# Access Compliance Report

## Public Rights-of-Way

### (Curb Ramps)

Intersection ID: 27452	Main Street: BALLANTYNE COMMONS PY	Cross Street: BALLANTYNE CORPORATE PL	Location: NW
ADA ID: F819A02C9E30	Ramp Type: Directional1	Initial Pass/Fail: Fail	Overall Compliance: No
Severity Score: 8.75			
Codes/Mitigation Info/Possible Solution		Field Measurements/Component Compliance

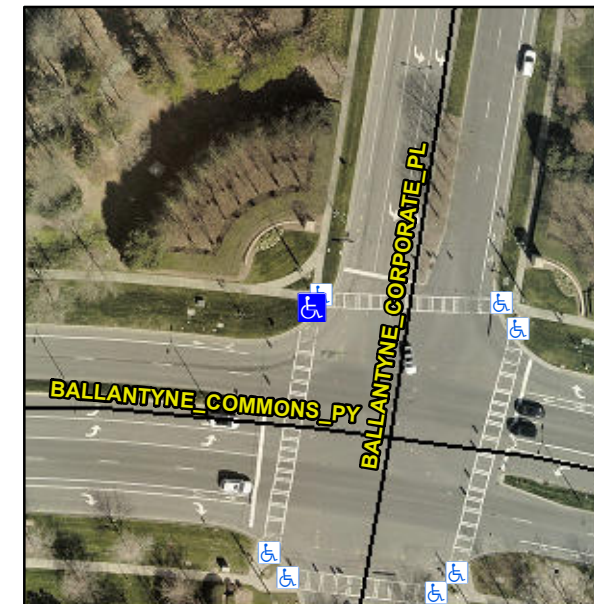
**Remove & Replace Entire Ramp.**

**R304.5.1**
